Service-Information Motorcycle

April 1989
61 019 89
(2342)

Brake Light Switch Recall

BMW of North America, Inc. has voluntarily initiated a safety-related Recall Campaign. The NHTSA-assigned Recall Campaign number is 88V-192.

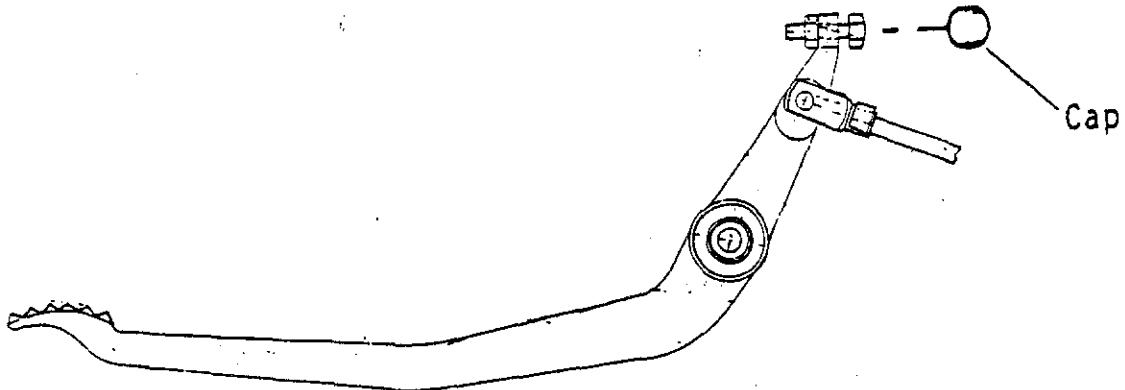
To inspect the **front** Brake Light Switch, remove the front brake lever and, using a flashlight, determine the color of the plastic pin.

To inspect the **rear** Brake Light Switch, position a small mirror between the swing arm housing and right footpeg bracket. Press the brake lever down to allow the plastic pin to come out of the switch. Using a flashlight, determine the pin color.

If either or both switches have a White plastic pin, replace the switch(es) - see heading "Switch Replacement".

Remedy No. 1: Visually inspect the front and rear Brake Light Switch to determine the color of the pin at the end of the switch. Switch (Part No. 61 31 1 459 519) with the **White pin is the older type and must be replaced** with switch (Part No. 61 31 1 459 569). Switches with a **Black** or **Dark Gray** plastic pin are the new type and need not be replaced.

Brake Lever Modification:

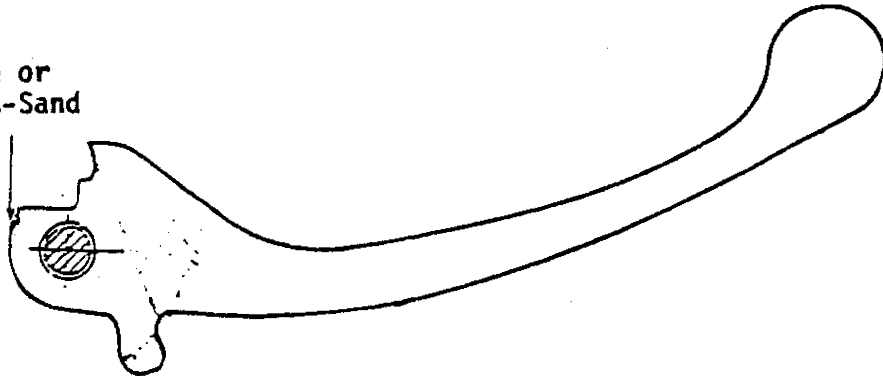
Remedy No. 2: File the small ridge off the front brake lever, as described below. This ridge may tend to force the plastic pin to one side, causing the pin to bind inside the switch housing.

Remove the sharp ridge with a file or belt sander.

**File or
Belt-Sand**
